## ARMED FORCES RADIOBIOLOGY RESEARCH INSTITUTE

June 29, 2001

The Armed Forces Radiobiology Research Institute (AFRRI) reactor facility requests to amend the Technical Specifications for license R-84 (Docket 50-170) with the changes described in Enclosure 1. A change bar in the right margin shows proposed changes. These changes are necessary to comply with the new 10 CFR 50.59 as well as to provide for more efficient reactor operation. These changes are also in preparation for submittal of the reactor-relicensing package in 2003 and we request that they be reviewed using relicensing criteria. In reformatting the document, numerous lines of text moved to different pages. We are therefore resubmitting the entire document (at Enclosure 2) as proposed Amendment 24.

## Technical Specifications Summary of Proposed Changes

Figure 1. Organization of Personnel for Management and Operation of the AFRRRI Reactor Facility

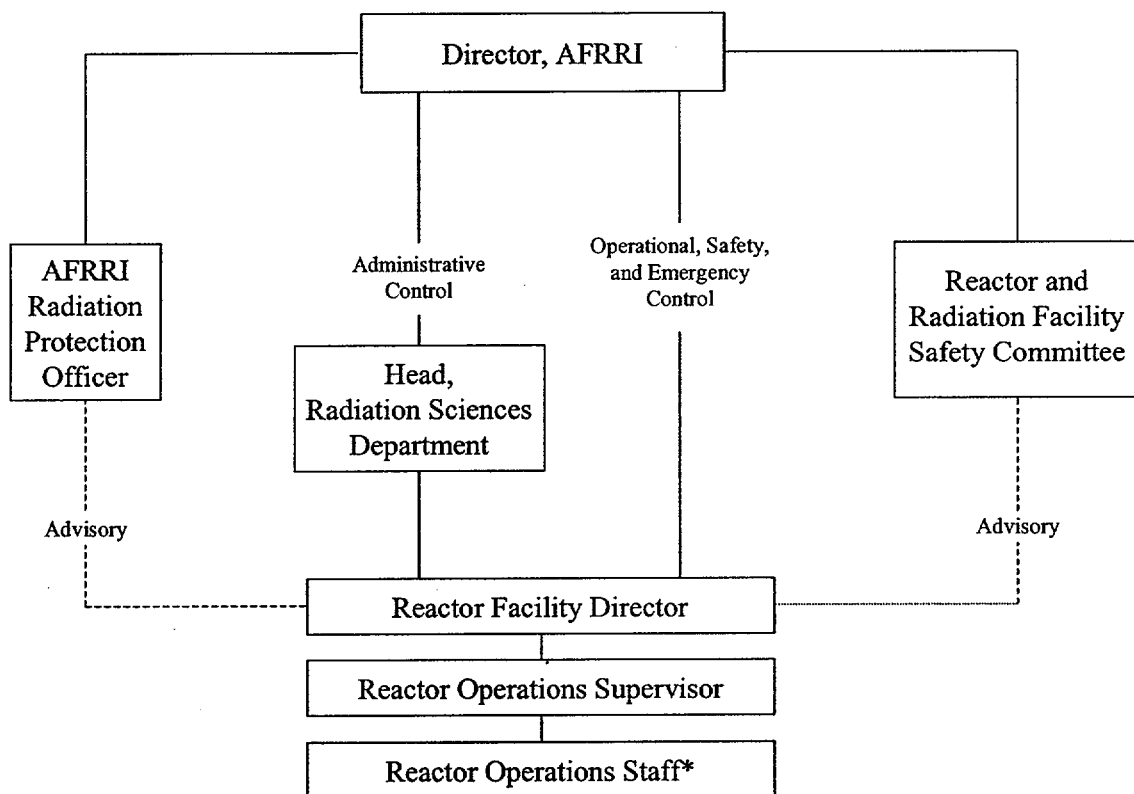
6. Section 6.1.1 - In the organization chart, change "Radiation Sources Department" to "Radiation Sciences Department" to conform to current AFRRRI usage. This in no way affects reactor operation or safety.
